CORRECTION INDEX - MECANOGRAM

Correction Index - Mecanogram No. 1005 includes those Series C Mecanogram items which may be considered as having current value that were previously announced in Mecanogram through No. 597.

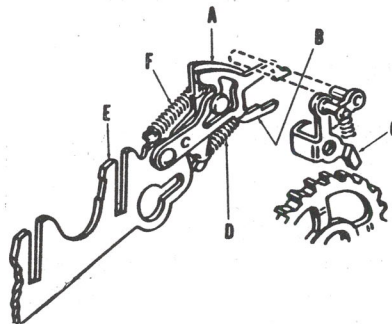
CONDITION: Over addition.

CAUSE: Failure of latch M (Plate 4, Series C Symbol Book) to remain locked on the tie strip when a key is flicked and only partially depressed. Should the drive pawl make contact on the high point of a tooth in the drive gear it will allow latch M to raise prematurely and release the indexed key during the machine operation.

CORRECTION: Replace indexing slide C and drive pawl P with improved drive pawl C (illustrated), index slide E and springs D and F.

Index slide E contains cam A which is riveted to latch B and held in its raised position by springs F and D. Cam A when depressed by actuation of the drive pawl, increases the spring tension on latch B sufficiently to hold the latter fully indexed on the tie strips regardless of the drive pawl's position on the drive gear teeth.

A longer stud has been added to drive pawl C to actuate the cam of the new index slide.

Check for safe clearance between the stud and motor brackets AM (Plate 22) when installing.

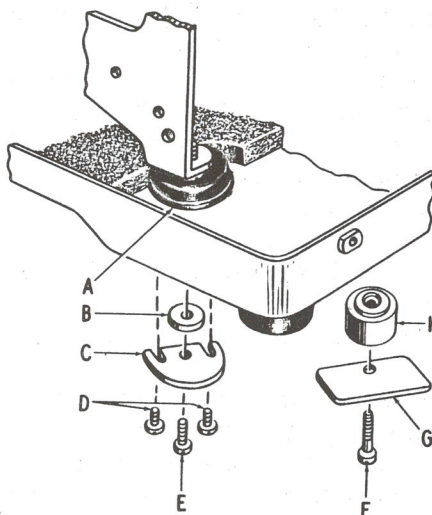
CONDITION: Replacement for Type 5 Motors 21-4567 No. 2 (AN, Plate 25, Series C Symbol Book).

CAUSE: Type 5 Motor 21-4567 No. 2 is not available as a complete unit.

CORRECTION: Install stripped Type 5 Motor 1Z-4567 No. 2 for replacement. End plate hangers 51103 No. 2 are not available and should be transferred from the old motor to the new one.

Other accessories such as switch assembly, governor, governor brush holder etc., may also be transferred to the new motor if in servicable condition.
